BENT GRASS EAST COMMERCIAL FILING 3

PRELIMINARY PLAN

PCD#: SP-20-010

Prelim plan V_3 comment planning only.pdf Markup Summary

ALTERNATIVE LANDSCAPE PLAN

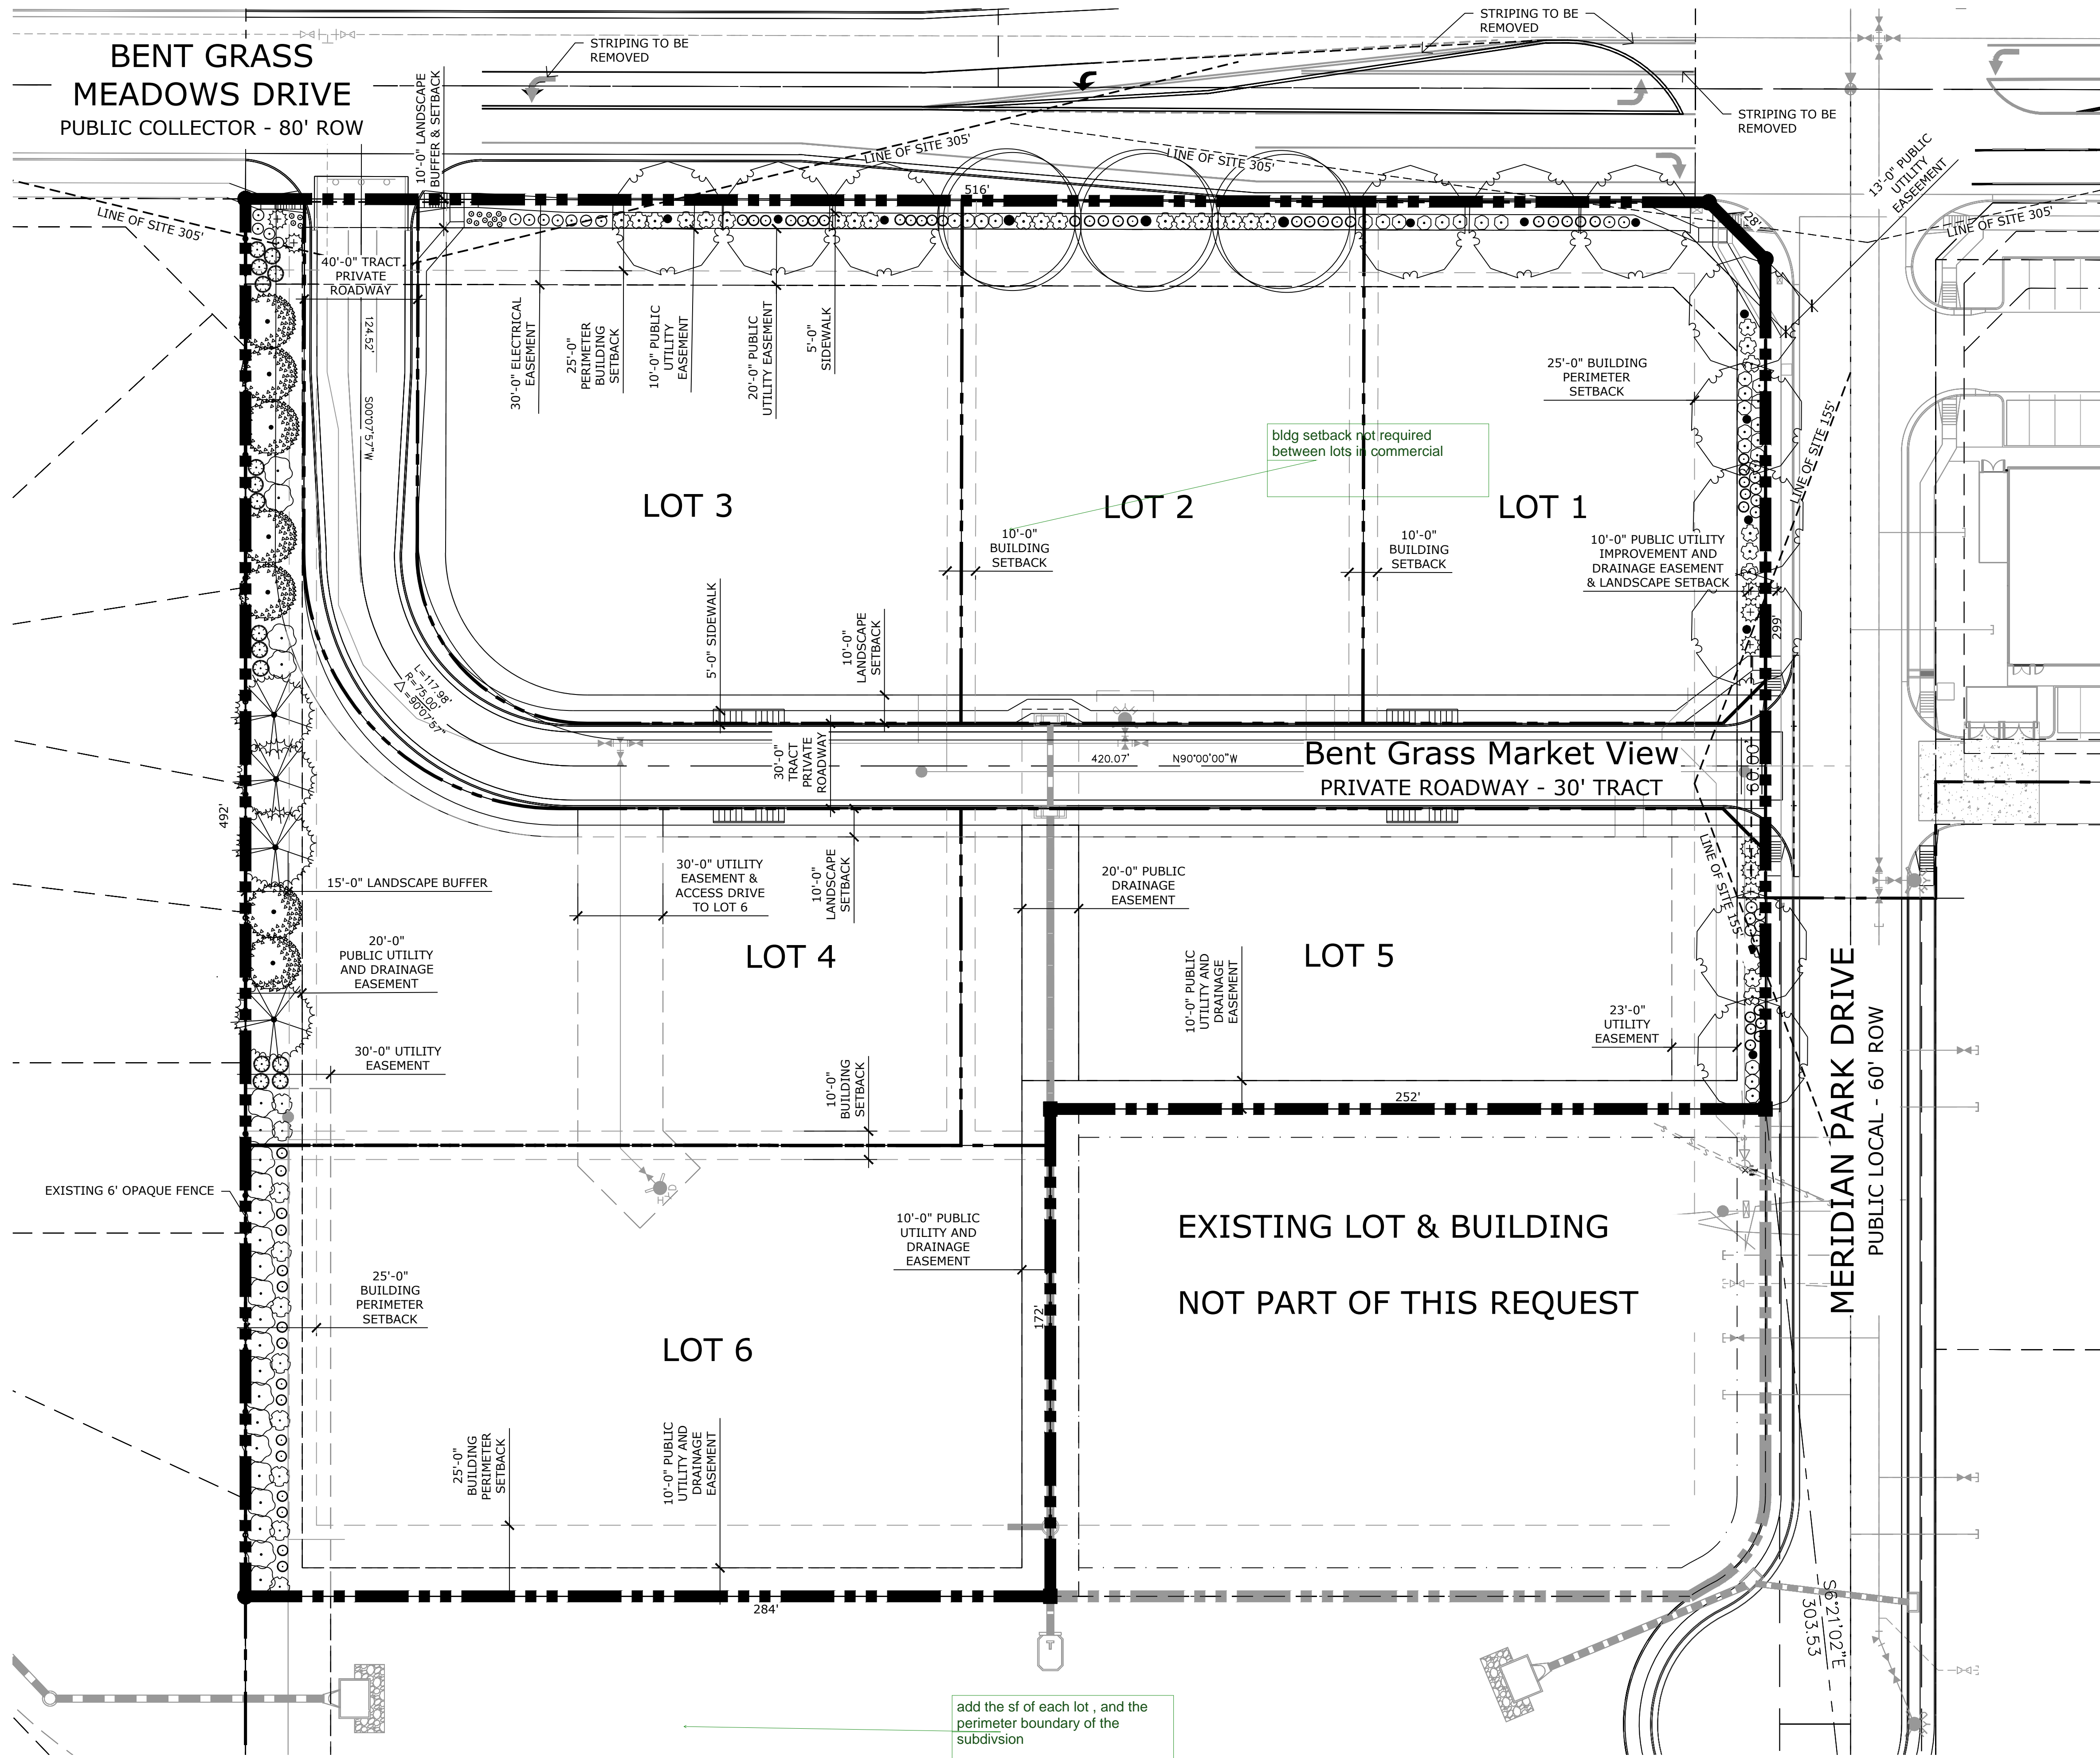
bldg setback not required between lots in commercial

add the sf of each lot , and the perimeter boundary of the subdivision
